19L ABWR Shutdown Risk Evaluation

The information in this appendix of the reference ABWR DCD, including all subsections, tables, and figures, is incorporated by reference with the following departures.

Figure 19L-3 Potential Path for Draining RPV Through Residual Heat Removal System (Pump On)

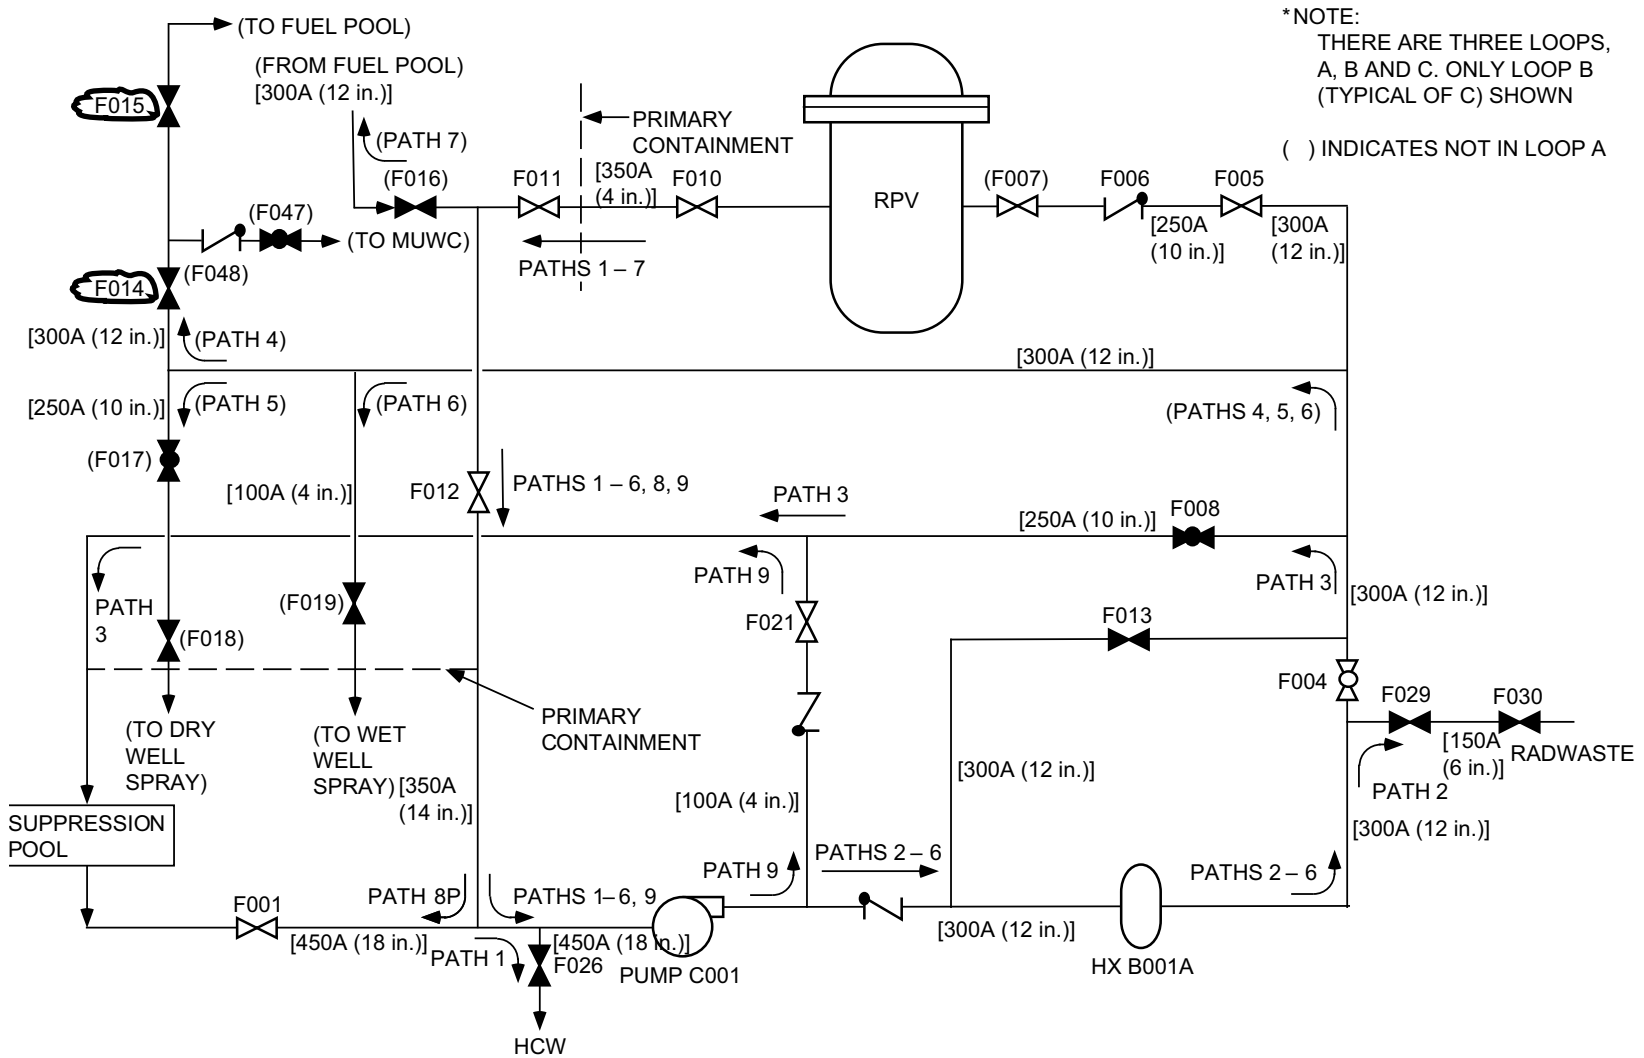
STD DEP T1 2.4-1 (Figure 19L-3)

STD DEP T1 2.4-1 (Figure 19L-3)

STD DEP T1 2.4-1

The ABWR residual heat removal (RHR) system is a closed system consisting of three independent pump loops (A, B, and C-where B and C are similar) which inject water into the vessel and/or remove heat from the reactor core or containment. Loop A differs from B and C in that its return line goes to the RPV through the feedwater line whereas loop B & C return lines go directly to the RPV. In addition, loop A does not have connections to the drywell or wetwell sprays. ~~or a return to the fuel pool cooling system.~~ However, for purposes of this analysis, the differences are minor and the three loops can be considered identical. The RHR system has many modes of operation, each mode making use of common RHR system components. These components are actuated by the operator; hence, the operation is subject to operator error which could potentially lead to drainage of the RPV. Potential paths for draining the RPV through the RHR system during operating Modes 4 and 5 are discussed below, summarized in Table 19L-8 and depicted in Figure 19L-3. Of the various modes of RHR operation it was judged that the potential for RPV draining was the greatest during the shutdown cooling mode. Therefore, the potential RPV draining paths start with the RHR in the shutdown cooling mode of operation. As will be shown by the following consideration and analysis, the probability of draining the RPV through the RHR system is negligibly low. Even if all the preventive and mitigative features fail, RPV draining will stop when the RHR shutdown cooling nozzle is uncovered at which point there is still 1.6 meters of water over the top of the active fuel.

The residual heat removal (RHR) design will have three RHR loops connected to the fuel pool cooling and cleanup system (FPCCS) instead of two for the reference ABWR DCD with normally closed inter-ties to permit additional supplemental cooling during refueling outages to reduce outage time.

Increasing the number of RHR loops connected to FPCCS from two to three results in a decrease in CDF, because it is an improvement of the outage management control for the fuel pool cooling system.
